# Baseline proposal for 100, 200 and 400 Gb/s Backplane

Clint Walker, Alphawave IP

## Changes to Annex 93A to implement this proposal (1 of 3)

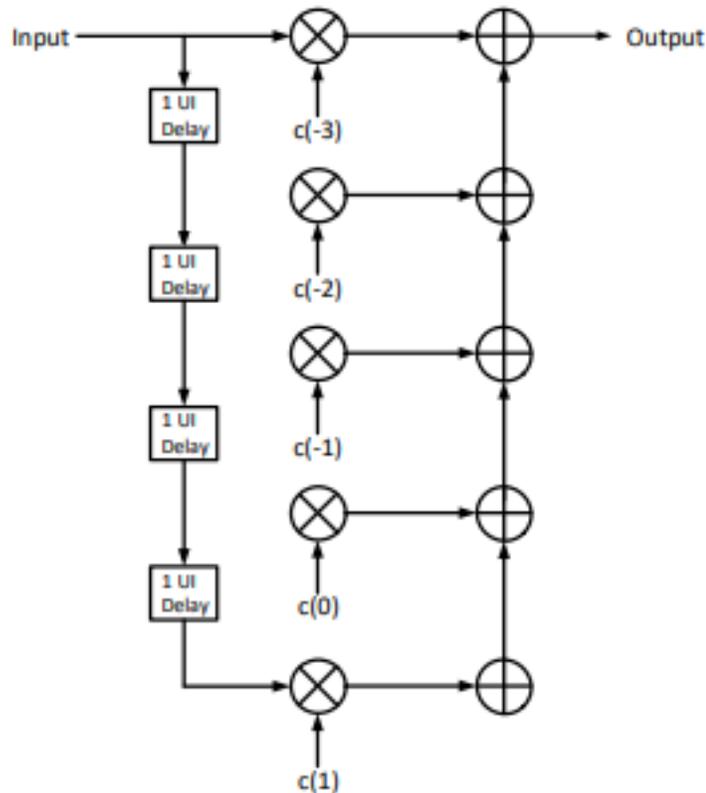
## Changes to Annex 93A to implement this proposal (3 of 3)

### 93A.1.2.4 Assembly of transmitter and receiver device package models

The scattering parameters for the transmitter device package model  $S^{(tp)}$  are the result of the cascade connection of the device [capacitance model](#), package transmission line, and board capacitance as defined by Equation (93A–15) [and Equation \(93A–15a\)](#).

Similarly, the scattering parameters for the receiver device package model  $S^{(rp)}$  are the result of the cascade connection of the board capacitance, package transmission line, and device [capacitance model](#) as defined by Equation (93A–16) [and Equation \(93A–16a\)](#).

$$\underline{S^{(td)} = \text{cascade}(\text{cascade}(S^{(d)}, S^{(s)}), S^{(b)})} \quad \underline{(93A-15)}$$

$$S^{(tp)} = \text{cascade}(\text{cascade}(S^{(td)}, S^{(l)}), S^{(p)}) \quad (93A-15a)$$

$$\underline{S^{(rd)} = \text{cascade}(\text{cascade}(S^{(b)}, S^{(s)}), S^{(d)})} \quad \underline{(93A-16)}$$

$$S^{(rp)} = \text{cascade}(\text{cascade}(S^{(p)}, S^{(l)}), S^{(rp)}) \quad (93A-16a)$$
